**ARBORICULTURAL IMPACT ASSESSMENT
ADDITIONAL INFORMATION REQUEST
Subdivision—Lot 4, 7 Trentwood Park, Avalon.**

I write regarding the letter (the letter) from Matthew Edmonds of Northern Beaches Council (Council), dated 28 August 2019, regarding Development Application DA2019/0393 for the subdivision of one lot into two at 7 Trentwood Park, Avalon (the site).

Figure 1 – illustrates the indicative type of concrete anchor proposed to be seated on the 1m wide pebble stabilising bed.

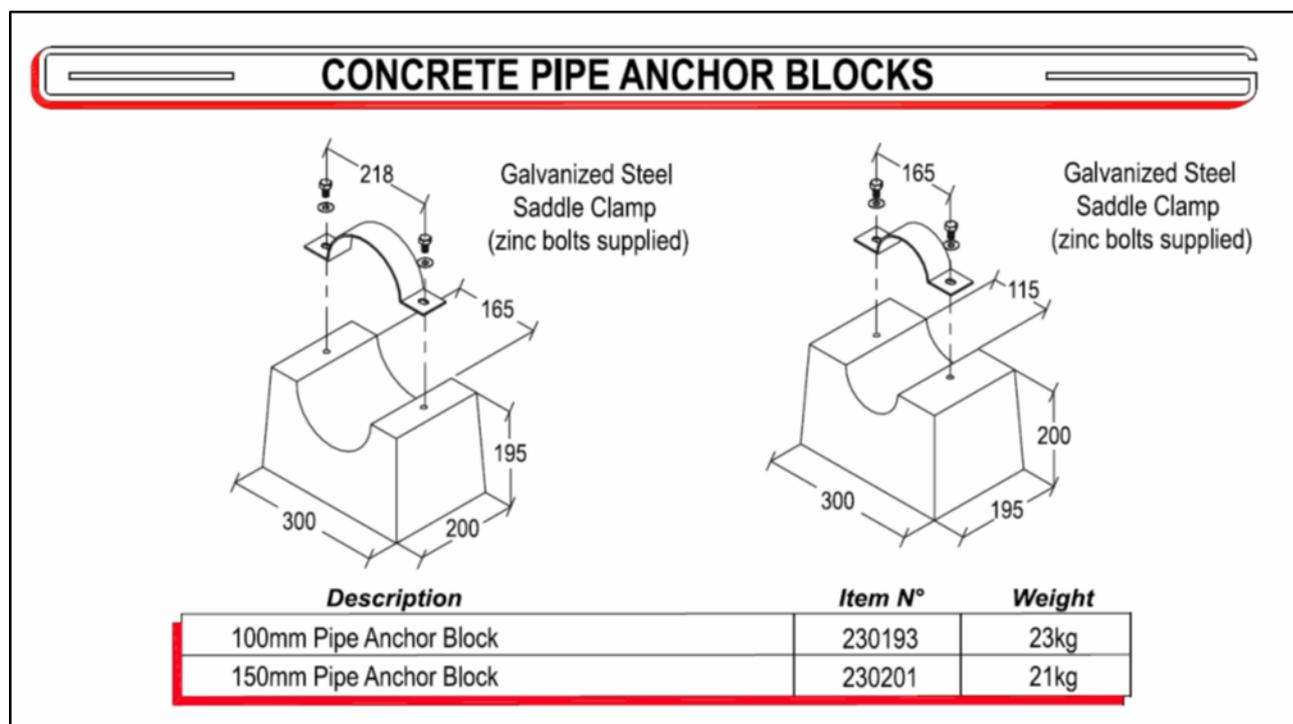
- Concrete pipe anchor blocks at approximately 6m centres would be placed on the pebble bed to stabilise the above ground pipes (see Figure 1). No excavation is required to seat these anchors.

Excerpt of Plan DA-01 (K) 1711 Lot 4, dated 10/09/19. Please refer to full plan for details.
 Note notional encroachment of Tree 3 indicated by pink shaded area.
 Plan not to scale. Marked up by C. Mackenzie 10/09/19

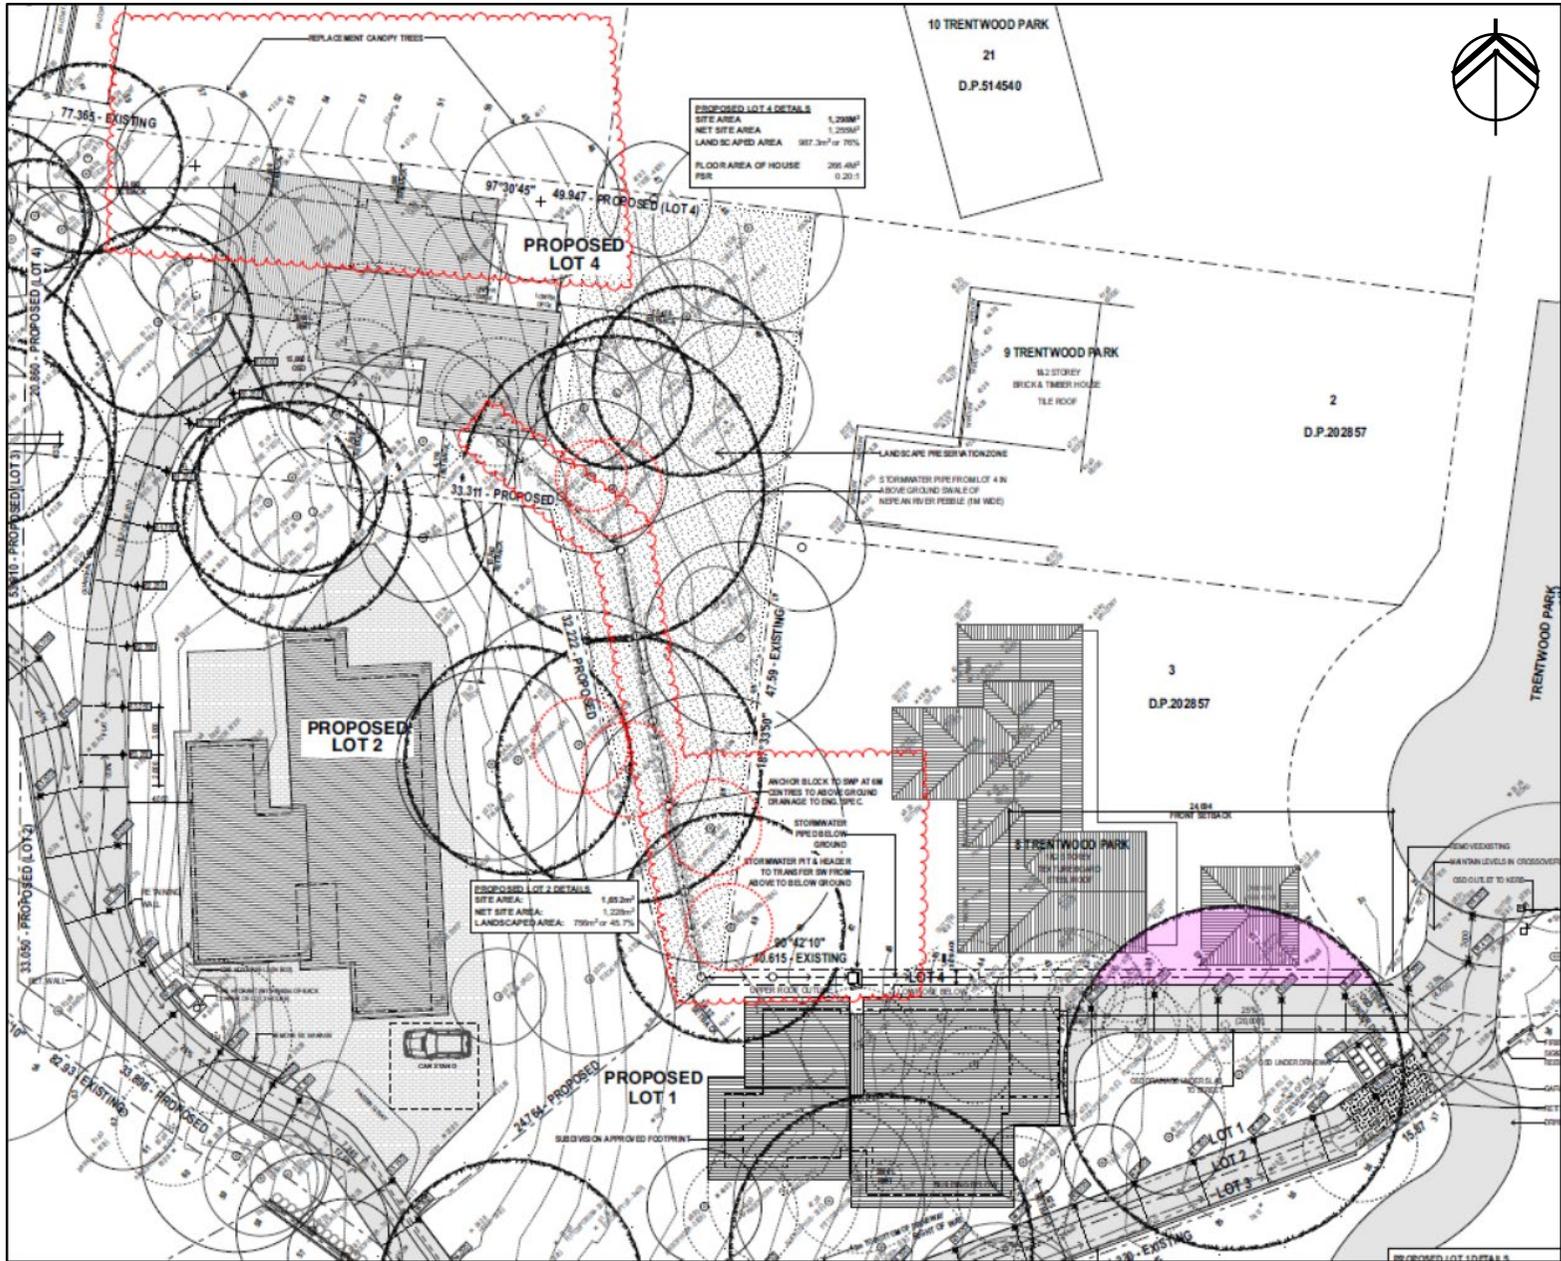
- The pipe from the proposed pit at approximately RL47.00 to the street will be below ground. There is an estimated 63m² of the notional Tree Protection Zone of Tree 3 potentially affected by trenching. This suggests approximately 17.2% of the tree's 366m² TPZ area will be encroached upon.

- However, the encroachment will be less than this as there is an existing carport reducing the TPZ area and the trenching will be a temporary encroachment as, following trenching and replacement of soil, the ground will be available for tree roots to regenerate back into this area.

- The tree is in good health and vigour and would be expected to tolerate this trenching, as the Lot 1 works within the TPZ are elevated to avoid tree root disturbance and loss.
- Under the provision that the tree is subject to arboricultural supervision of the works for the elevated driveways where they fall within its notional TPZ offset, I do not expect the tree to be adversely affected.

- Planting of two (2) canopy trees is proposed. Given Lot 4 is virtually covered in tree canopy, the only potential area for tree planting is in the northeast and northwest areas adjacent to the proposed building footprint.
- It is proposed to plant a 25 litre *Eucalyptus umbra* (Broad-leaved White Mahogany) in each location shown on the attached plan excerpt.
